**King's Mark  
Environmental  
Review  
Team  
Report**

**BETHANY FARMS  
SUBDIVISION  
BETHANY,  
CONNECTICUT**

Environmental Review Team Report

FEBRUARY 1988

Figure 2

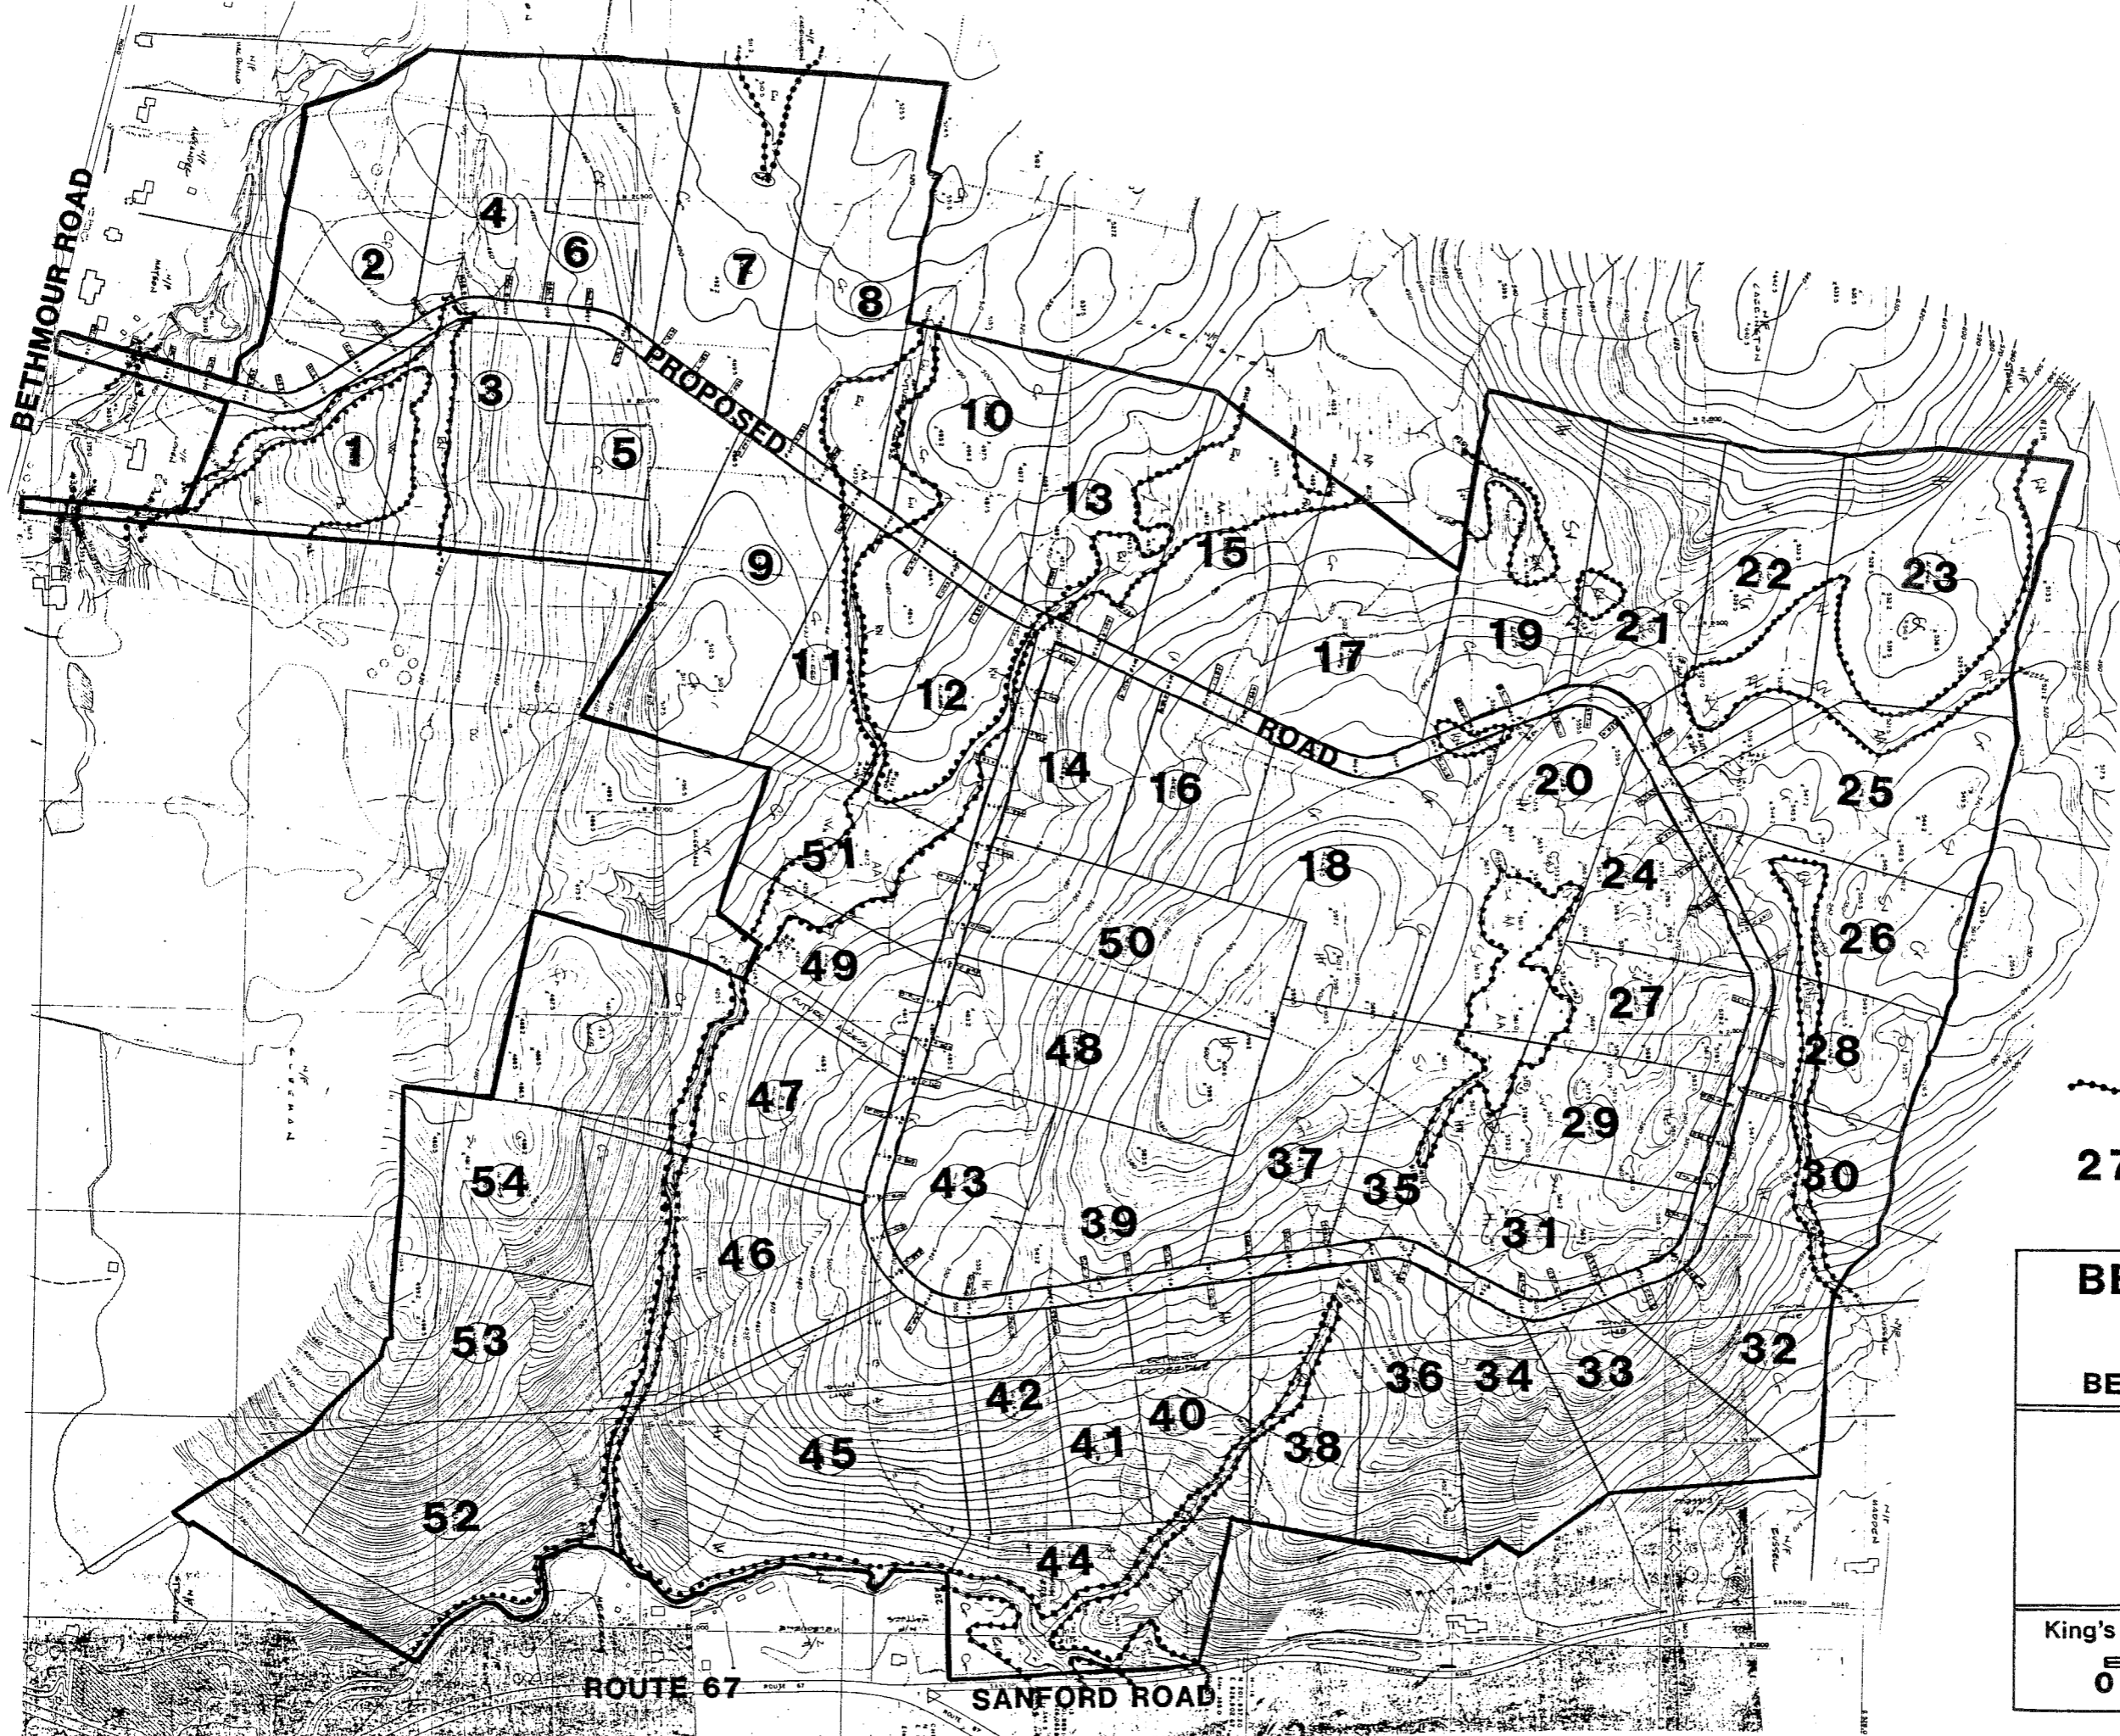
Based on the subdivision plan submitted to Team members, the present interior road system will cross wetland areas in at least five locations. It appears several small drainageways that carry seasonal waters will also need to be crossed. All crossings except one (near lots 8 and 10), consist of relatively narrow bands of wetlands. This one crossing consists of about 90 feet of regulated soils. Shifting the road approximately 100 feet to the south would reduce the amount of the wetland crossing significantly.

Based on present plans and visual observations made during the field review, it seems likely that a large volume of fill would need to be placed on regulated soils in order to construct the section of road near the intersection of the loop road in central parts. In order to minimize wetland disturbance in this area, it is suggested that consideration be given to shifting the road eastward.

5. Areas shown as "future access" between lots 47 and 49 and 8 and 10 may be poorly located since wetlands and watercourses could be highly impacted.
6. Lots 52, 53 and 54 have major limitations for driveway access with very steep slopes, shallow soils and watercourse crossings. Driveways should be planned on the contour as much as possible.

7. Other lots with major limitations of very steep slopes, watercourses and shallow soils are lots 32, 33, 34 and 36, and 41, 42, 44, 45, 46, 52, 53, and 54.
8. Lots 22, 23, 25, 26, and 28 contain large areas of moderately well to very poorly drained soils intermingled with slightly higher areas of bedrock controlled soils. It will be difficult to locate suitable house/septic system sites on these lots.
9. Wetland impact could be minimized if the loop road connection could be moved further east on lot #14.
10. During the review discussion it was mentioned that these lots may be marketed as "horse farmettes". However, there are very few lots with soils that, when cleared, could be developed into suitable pasture or paddock areas. Most of the soils are too droughty, too steep, or too stony or rocky.

The preliminary site plan, dated August 24, 1987, was reviewed. The proposed 57 house lots would be served by a new road built through the property with only one access point to Bethmour Road; the new road would be slightly greater than one mile in length.

Sharp curves and reverse curves (curving first in one direction then in the opposite direction) are considered to be dangerous because of the potential for cutting corners and going across the center line. Some of the curves on the subdivision plan could be made less severe. The alignment of the road might also be made smoother for easier driving. Better sight lines and easier turning movements are obtained by having road and driveway intersections form 90 degree angles, rather than the acute angles indicated. Any right-of-way set aside for proposed future access roads should also intersect with the main road right-of-way at 90 degrees.

the approaches. This is an excellent idea in case one bridge must be blocked or closed. The width of each bridge and approach road should be a minimum of 20 feet.
